COMMISSION REGULATION (EU) 2017/1347

of 13 July 2017

correcting Directive 2007/46/EC of the European Parliament and of the Council, Commission Regulation (EU) No 582/2011 and Commission Regulation (EU) 2017/1151 supplementing Regulation (EC) No 715/2007 of the European Parliament and of the Council on type-approval of motor vehicles with respect to emissions from light passenger and commercial vehicles (Euro 5 and Euro 6) and on access to vehicle repair and maintenance information, amending Directive 2007/46/EC of the European Parliament and of the Council, Commission Regulation (EC) No 692/2008 and Commission Regulation (EU) No 1230/2012 and repealing Regulation (EC) No 692/2008

Figure 1

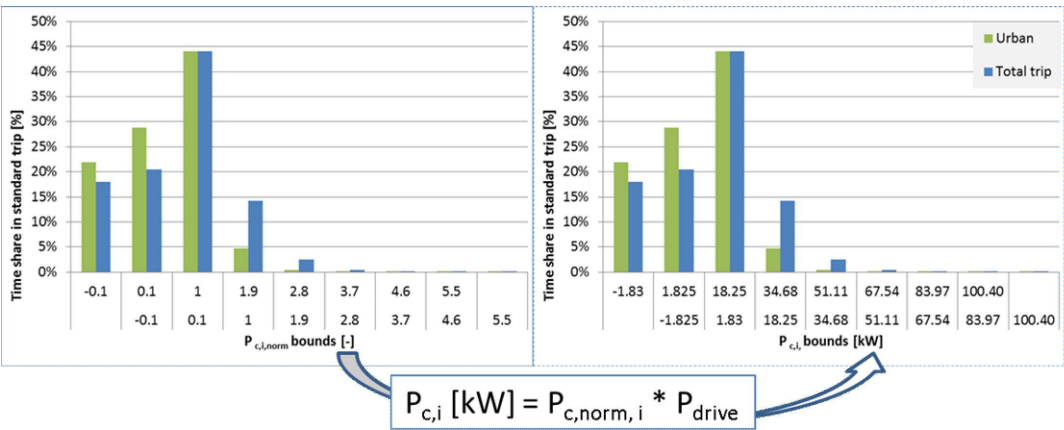
(v) point 3.4.2 is replaced by the following:

‘3.4.2. Correction of the wheel power classes

The maximum wheel power class to be considered is the highest class in Table 1 which includes ($P_{rated} \times 0,9$). The time shares of all excluded classes shall be added to the highest remaining class.

From each $P_{c, norm, j}$ the corresponding $P_{c, i}$ shall be calculated to define the upper and lower bounds in kW per wheel power class for the tested vehicle as shown in Figure 1.
